4. Detailed review of design report

Section 4 includes discussions that are specifically applicable to a single page or a few pages of SAI's design report. Some topics, of a more general nature, were previously discussed in Section 3, which complements Section 4.

FIGURE 4-1 - Basis for char cooler heat transfer calculations.

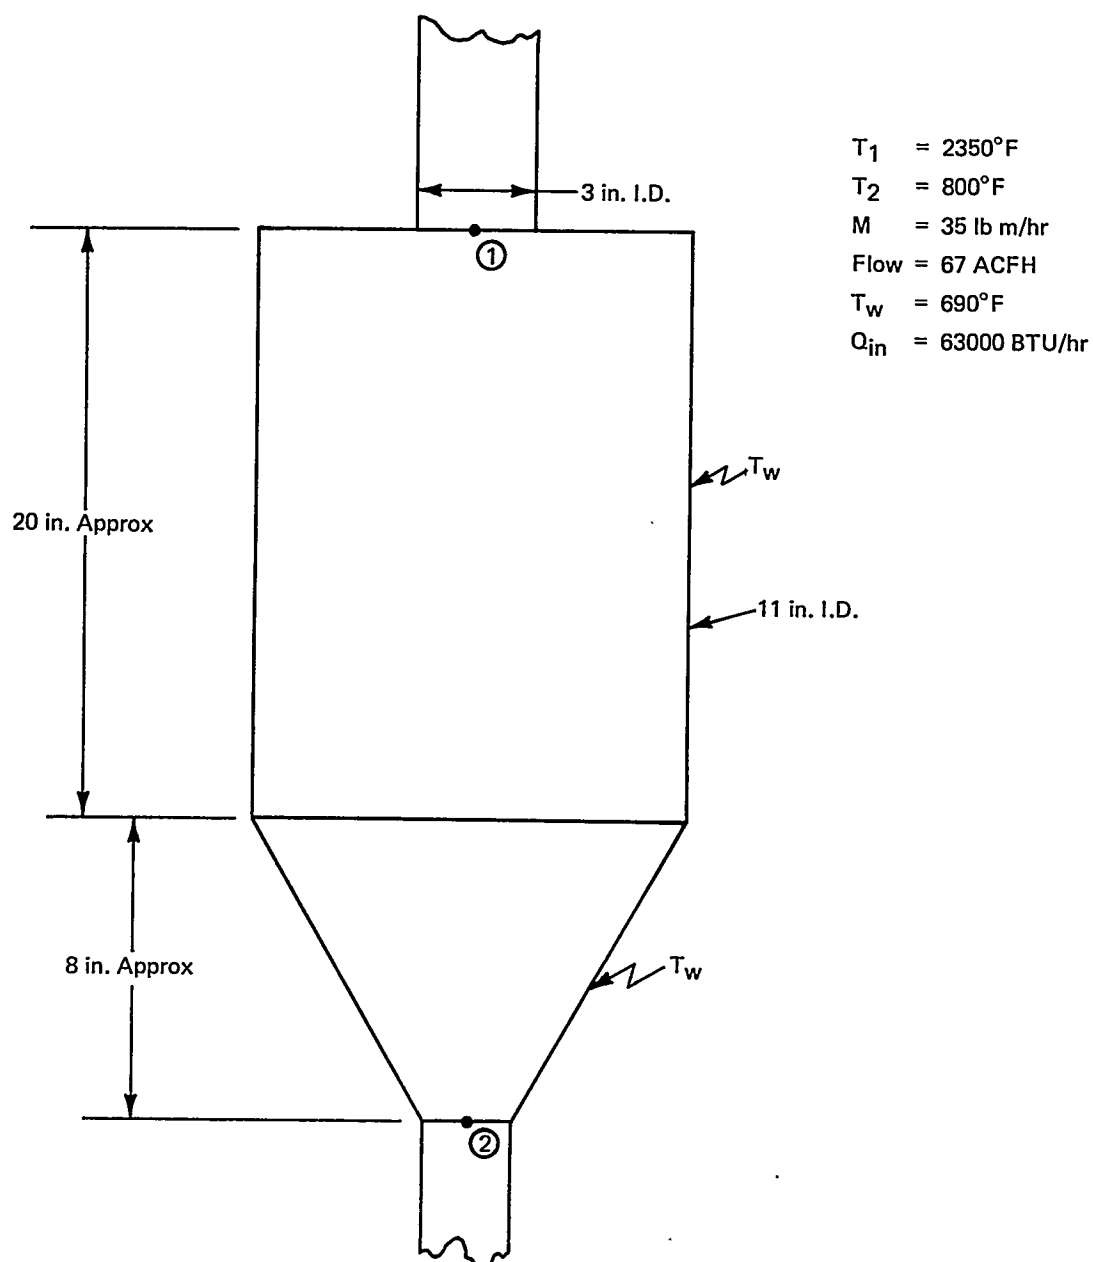
There is some concern regarding the ability of the char cooler to cool the char and gases adequately for worst condition cases. Thus, the following preliminary analysis was considered:

Note Figure 4-1 for the cooler conditions and sizes.

Compared to a maximum amount of energy to be removed of 63,000 BTU/hr, the heat exchanger calculations indicate an oversizing by a factor of approximately 2. With the aforementioned assumptions, particularly the constant wall temperature, this sizing would be appropriate. Finally, these calculations are preliminary and further analysis is advisable.
